U.S. Department  
of Transportation  
**Federal Highway  
Administration**

In Reply Refer To:  
HSST/SS-172

Name of system:	Omni-Directional Dent Connector Assembly
Type of system:	Breakaway Connectors for Sign and Luminaire Supports
Test Level:	NCHRP Report 350 Test Level 3
Testing conducted by:	Texas Transportation Institute
Date of request:	December 17, 2010
Request acknowledged:	December 22, 2010

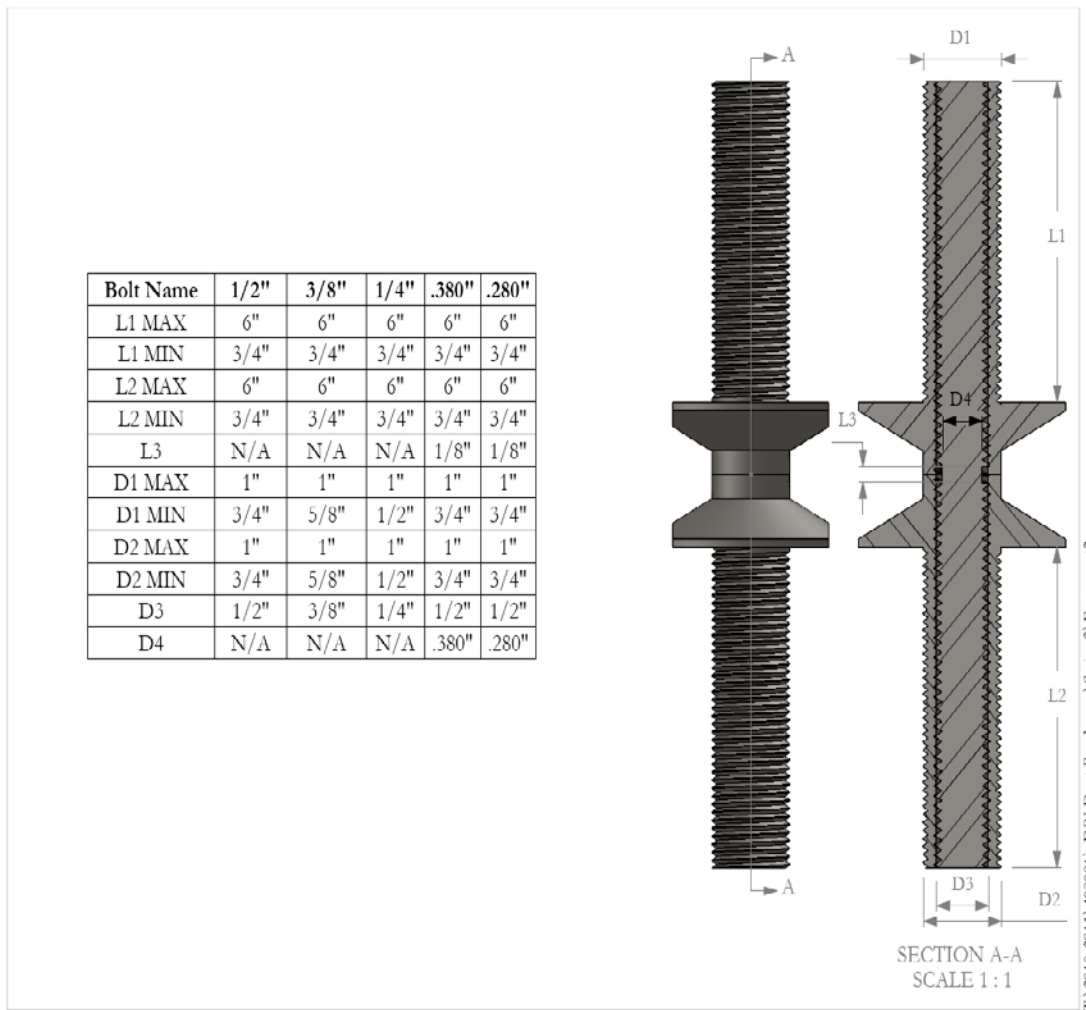
The table below shows the five (5) sizes of your Omni-Directional Connector Assembly that were found acceptable and a drawing of the assembled design consisting of an upper and lower end section and an internal threaded connector rod:

- All supports shall be mounted to a structural concrete foundation that will not move in the soil if the support is struck by a vehicle. Either your epoxy-embedded anchor or your embedded anchor with stabilizing plates may be used in the concrete footing to accept the Dent connector end section. Existing anchors, if undamaged in a crash, may also be used with your assembly.

- If used on dual supports closer than 2.1 m (7 feet) apart only the connecting rod with a 0.280 milled diameter may be used and the weight of the posts cannot exceed 27 kg/m (18 lbs/ft).

- The maximum diameter at the milled section of the connector rod is 0.280 inches for sign support legs up to 600 pounds with a maximum post size of 30 lbs/ft.

- Both your 0.280 and 0.380 milled connecting rods may be used with existing slip-base supports.
- Luminaire mounting height should not exceed 15.7 meters (55 feet).

- Mass of pole, mast arm, luminaire and other hardware above the couplings shall not exceed 454 kg (1000 lbs.).
